**MOUNT OWEN CONTINUED
OPERATIONS PROJECT**

Response to Submissions

REPORT A:
NSW Agency and Community Submissions

June 2015

Figure 2: Frequency of occurrence of PM₁₀ concentrations at Jerrys Plains, Merriwa and Wybong

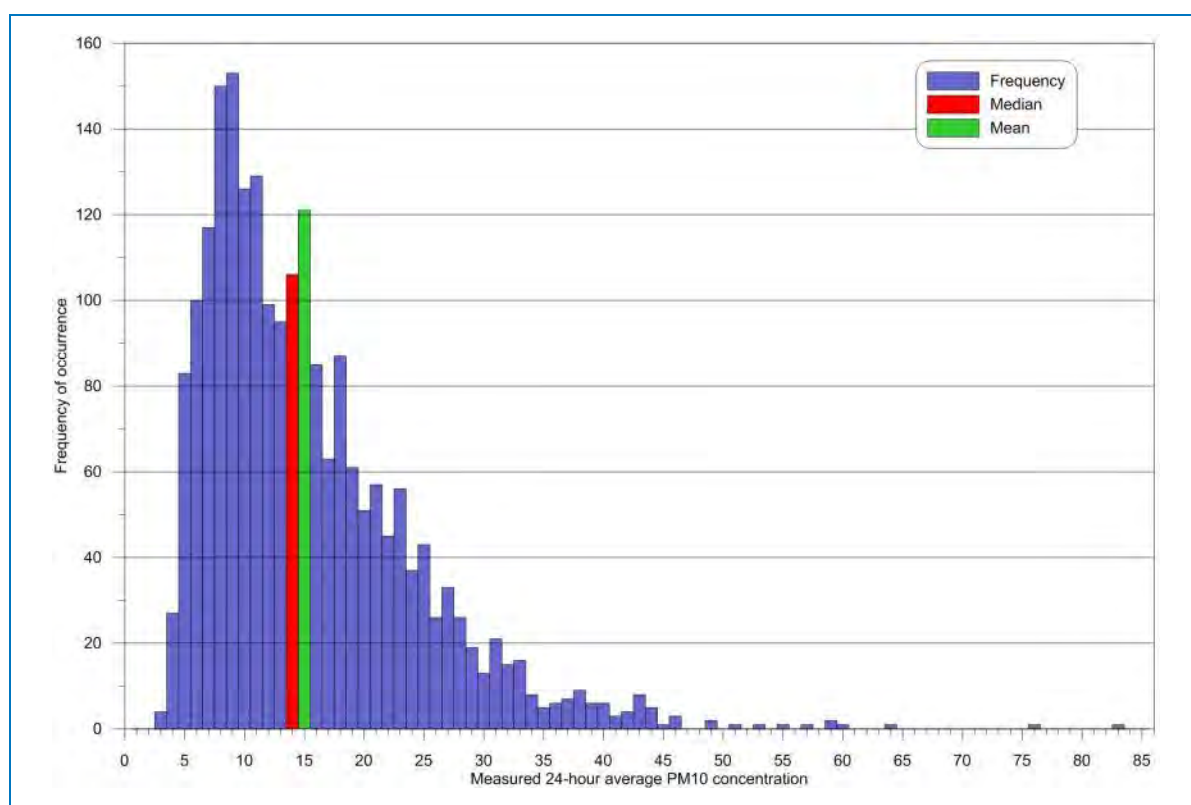
There was also a comment from the EPA relating to the way this value was determined and the potential reduction of the influence of extreme values. It is not explicit from the comment, but we assume this refers to the use of the median value rather than the annual mean (described in Section 5.3.2 in the AQIA). The median value was used to reduce the influence of significant weather events which are unpredictable into the future and can potentially skew the annual mean. **Figure 2** shows the frequency of occurrence of the 2,148 measured values from the Jerrys Plains, Merriwa and Wybong UHAQMN monitoring sites in ranges of 1 µg/m³. The median and mean values are shown in red and green, respectively.

As can be seen from **Figure 2**, there is a strong skew in the data with a higher frequency of occurrence of lower measured PM₁₀ concentrations. The histogram shows that the mean is slightly affected by the relatively few higher measurements, particularly those above the annual criterion of 30 µg/m³. Given that the median is closer in value to the most frequently observed concentration levels shown in the data, its use as the basis for the background levels in the cumulative PM₁₀ annual average assessment is considered to be appropriate.

Figure 6: Monitoring sites, source locations for existing mines and calibration grid

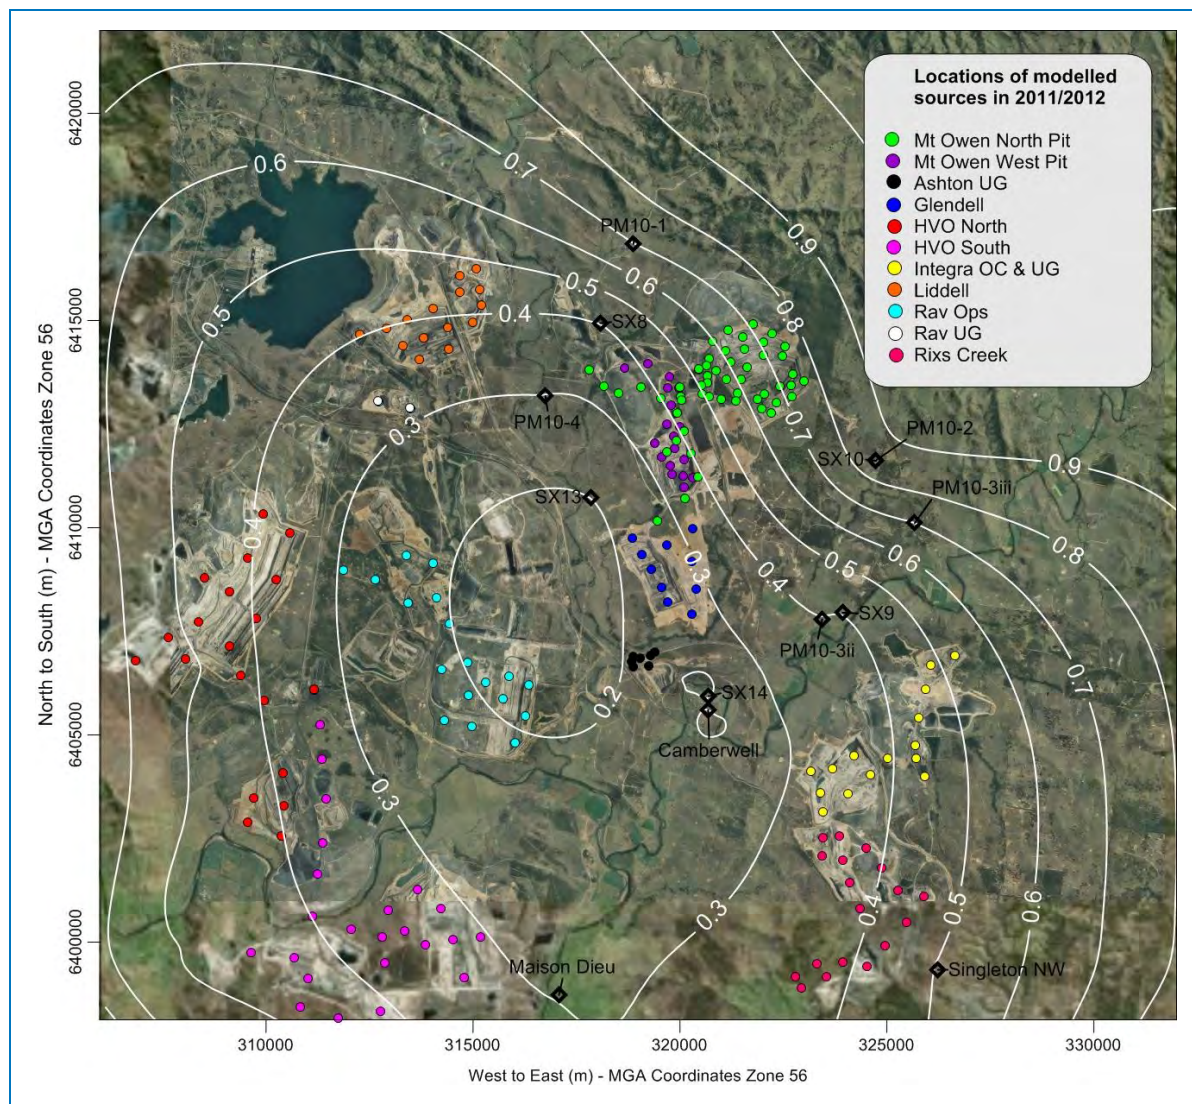
The calibration issue was discussed in detail in the meeting with the EPA and DP&E (28 May 2015). While the EPA and DP&E were generally supportive of the approach to further improve the accuracy of modelling, the following issues or areas of concern were raised in relation to the calibration approach used in the AQIA:

- The model performance was lower and was significantly over predicting concentrations in areas where other mines were the dominant source. The question was raised as to whether the model inputs were based on actual production or were derived from predictions in publically available assessment documentation.

- As noted in the EPA submission, there are areas of the model which have a calibration factor of 0.2 and modelling predictions of the contributions from other mining sources would be multiplied by 0.2 (divided by 5) in these areas. There was a concern that this level of calibration may remove the conservativeness in the modelled predictions, particularly given Camberwell Village was in an area with this 'higher' level of calibration.

It is important to understand that this calibration grid is only applied to the 'other mines' model output in the modelling of cumulative impacts for years 1, 5 and 10 off the Project. That is, the calibration is not applied to the Project, nor to the estimated 'background'. In other words, the following 'equation' is assumed:

Figure 7: Predicted cumulative annual average PM_{2.5} concentrations in Year 1 (µg/m³)

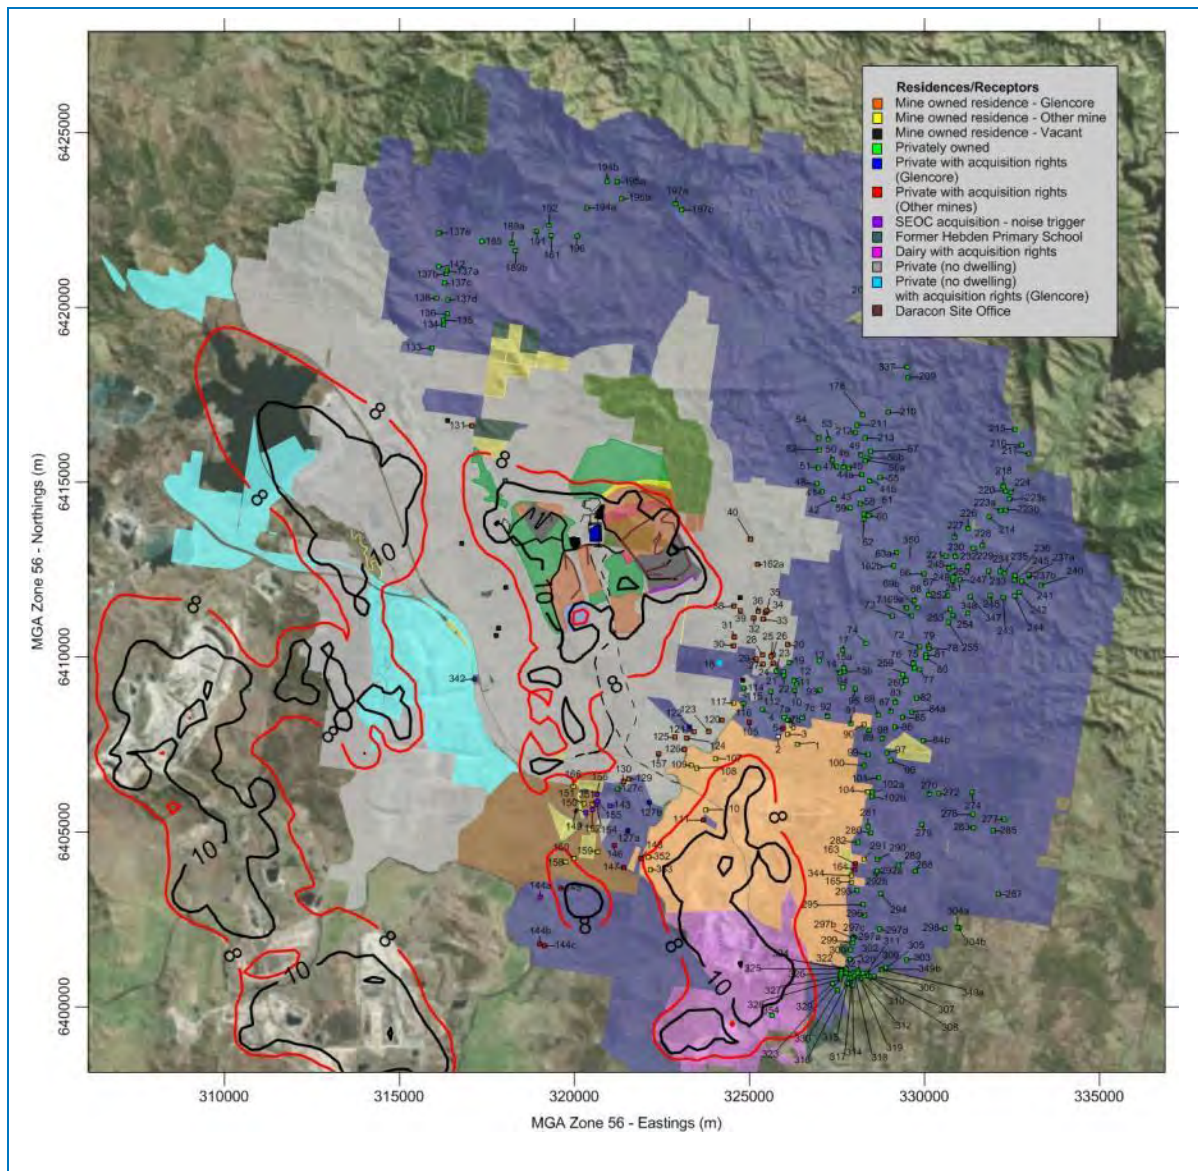
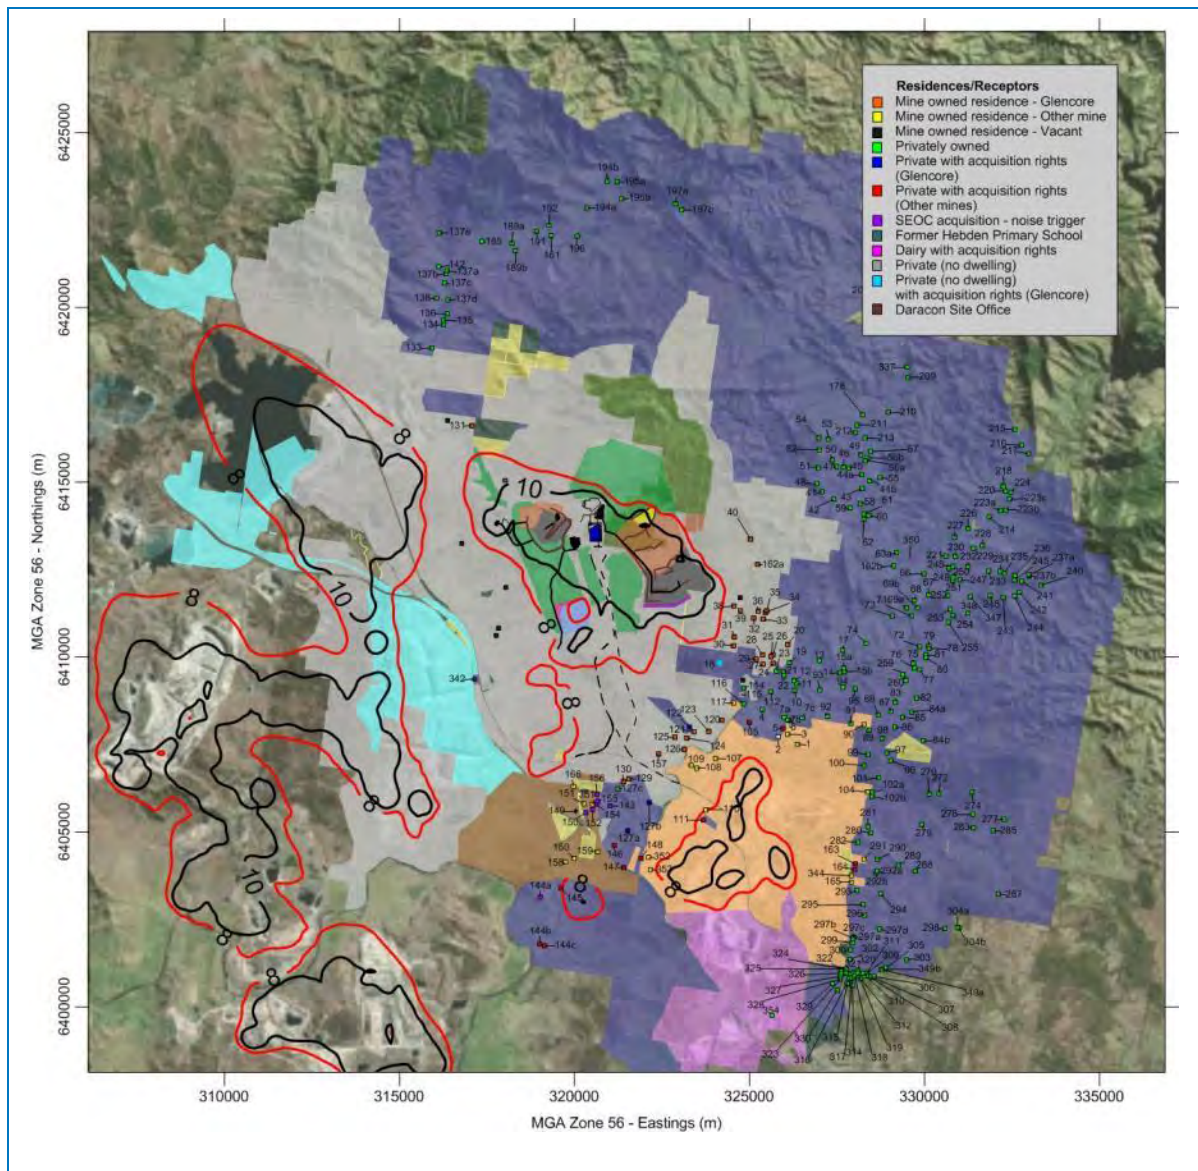
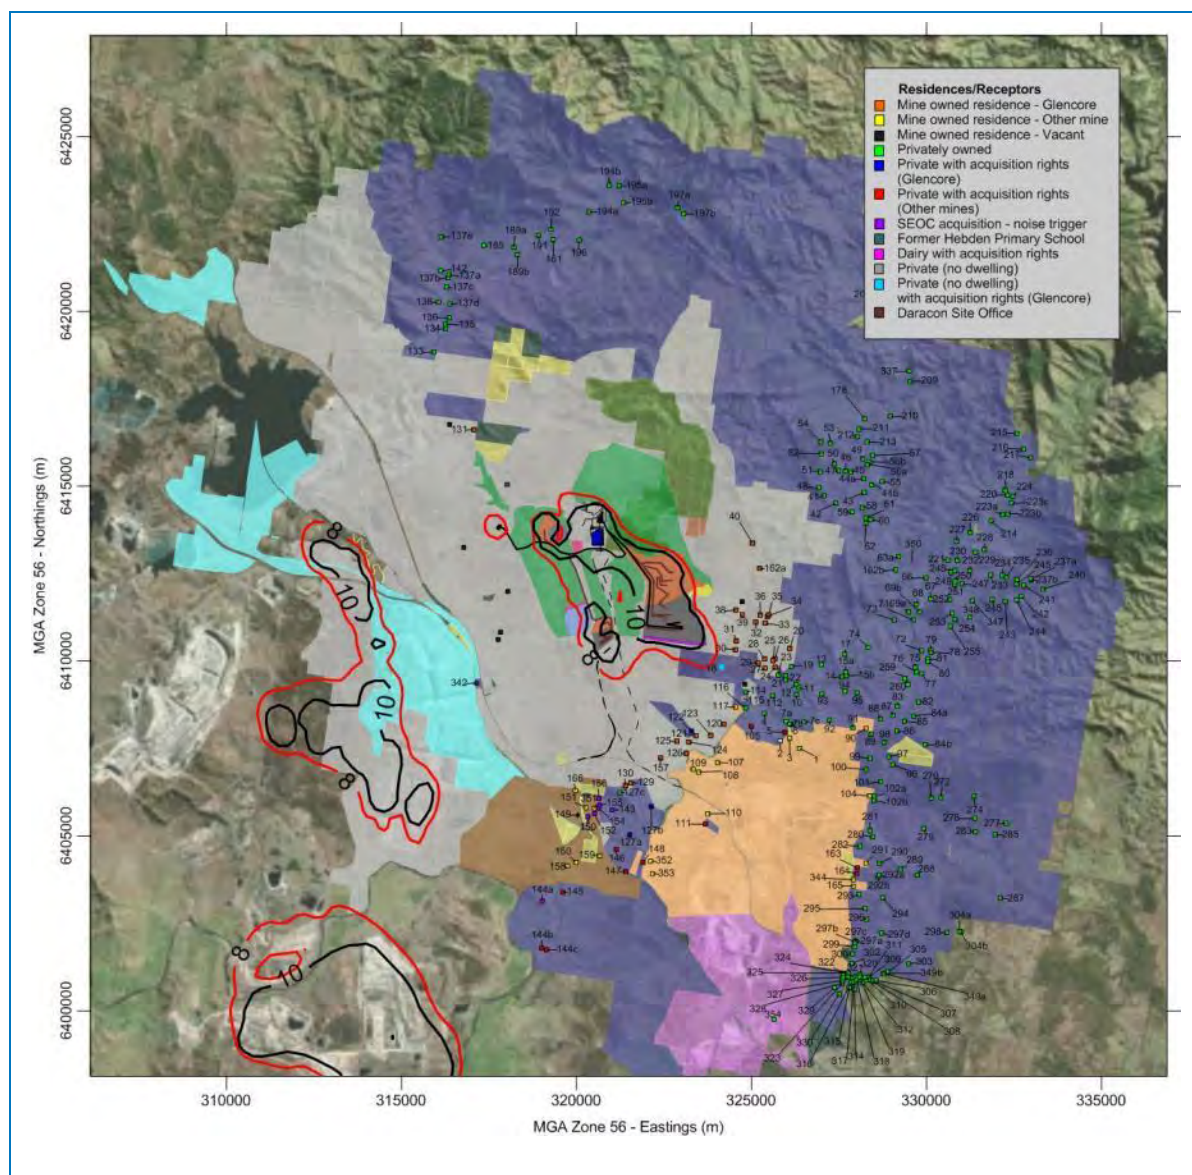
Figure 10.20 'Predicted annual average PM_{2.5} concentrations in Year 1 – Cumulative', on page 103, of Appendix 6 - Air Quality Assessment, identifies that many properties will be subject to annual average PM_{2.5} levels above the proposed NEPM standard of 8 µg/m³ however, the modelling suggests most of this impact will come from existing mines. Figure 10.21 'Predicted annual average PM₁₀ concentrations in Year 1 – Cumulative', page 104, identifies that many private residences will be subject to annual average PM₁₀ levels above 20 µg/m³. In excess of 30 residences in Wattle Ponds and to the north of Wattle Ponds (not mine owned or subject to acquisition will experience annual PM₁₀ levels above 20 µg/m³.

Using this updated estimation of 'background' PM_{2.5} (i.e. 5.3 µg/m³), the annual cumulative concentrations have been recalculated and the updated plots for Years 1, 5 and 10 are presented in **Figure 7, 8 and 9**, respectively.

Table 4 lists the residences that are predicted to exceed the annual average ARS of 8 µg/m³ using the background levels of 5.3 µg/m³. There are no predicted exceedances in Year 10.
